WASTE TREATMENT AND IMMOBILIZATION PLANT (WTP) LOW ACTIVITY WASTE
(LAW) STRUCTURAL REPORT

ORP Structural Peer Review Report

LAW Vitrification Building

Independent Structural Design Peer Review

Figure 5-1 Comparison of UBC-97 and IBC-2000 Spectra

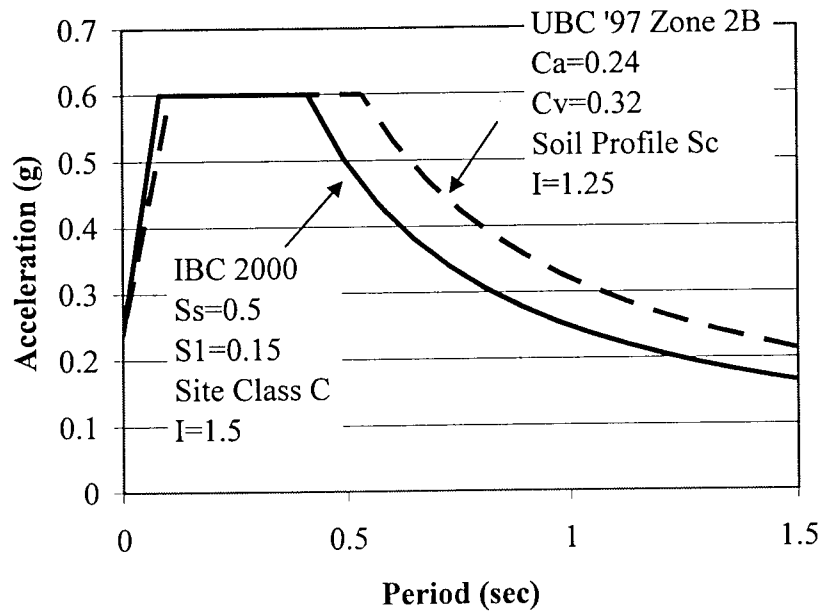
DOE-STD-1020-2002 references IBC-2000, with an importance factor, I , of 1.5 for PC-2 buildings. The IBC-2000 input spectra, with $I=1.5$, is compared to the UBC-97 seismic spectra used in the LAW design in Figure 5-1. These two spectra are essentially equal in the LAW fundamental period (about 0.4 sec). Thus, the seismic input used to design the LAW is consistent with DOE-STD-1020-2002.

Figure 7.3 UBC '97 Base Shear Spectra

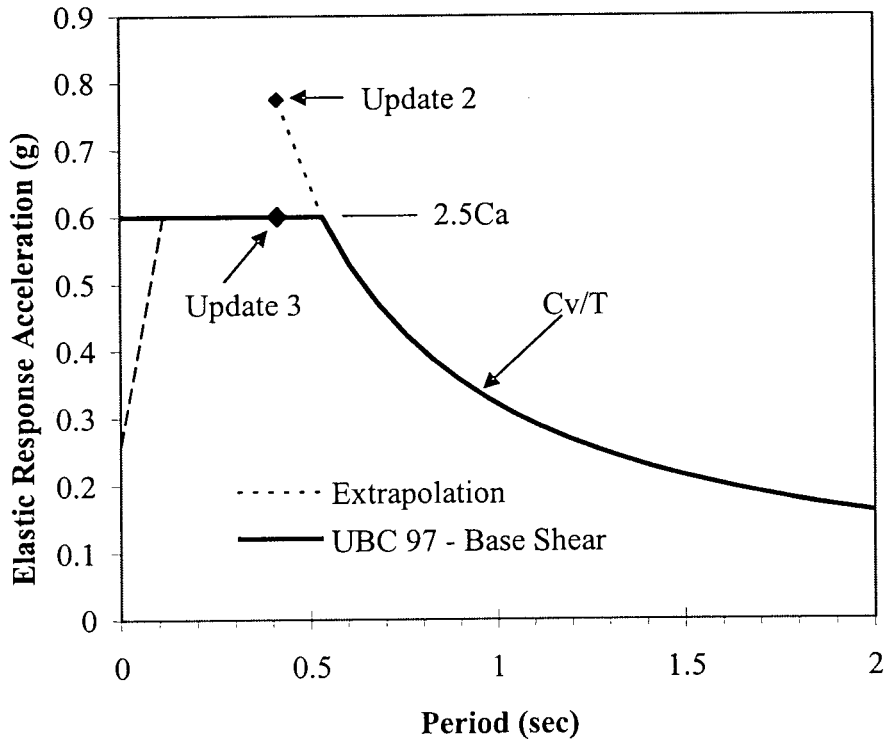
The free field spectra used to calculate the UBC '97 base shear is shown in Figure 7.3. In the long period, or constant velocity, portion of the spectra, acceleration is C_v/T , where C_v is 0.32g-sec and T is the natural period of the structure. In the short period, or constant acceleration, portion of the spectra, the acceleration is $2.5C_a$, where $C_a=0.24g$. From the original analysis, up to and including Update 2, the LAW seismic loading was determined by extrapolating the equation for the constant velocity portion of the spectra into the constant acceleration region. Beginning in Update 3 the correct portion of the spectra was used to determine seismic loads.

Figure 7.4 Cumulative Story Shears

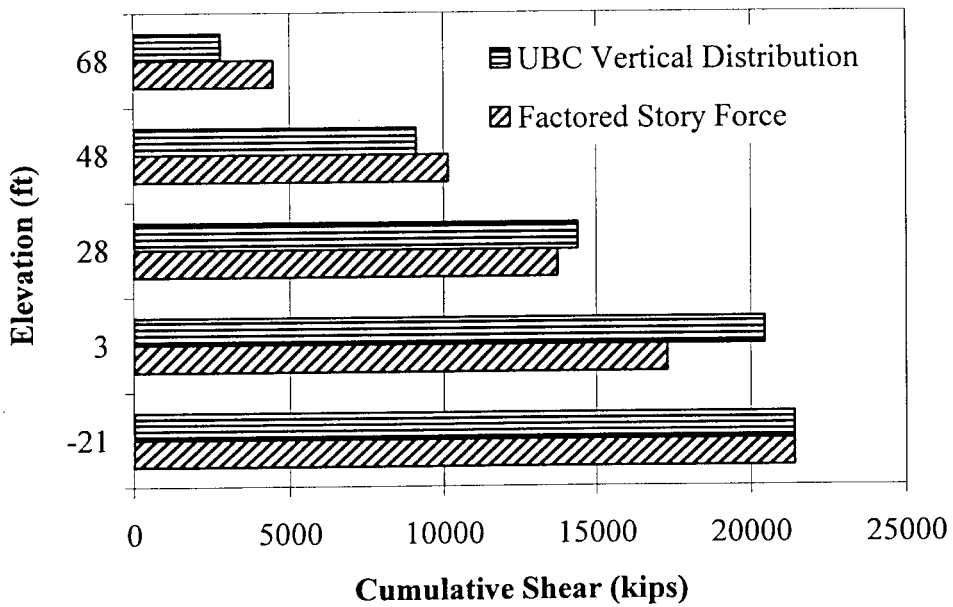
Cumulative shear is derived from Table 7.3 by summing the UBC Vertical Distribution and the Factored Story Force and is shown in Figure 7.4. Note that at elevations 28 ft and 3 ft the cumulative shear due to the factored modal story force is less than the UBC vertical distribution. The PRT recommends that BNI justify the use of the cumulative shear distribution in their design.
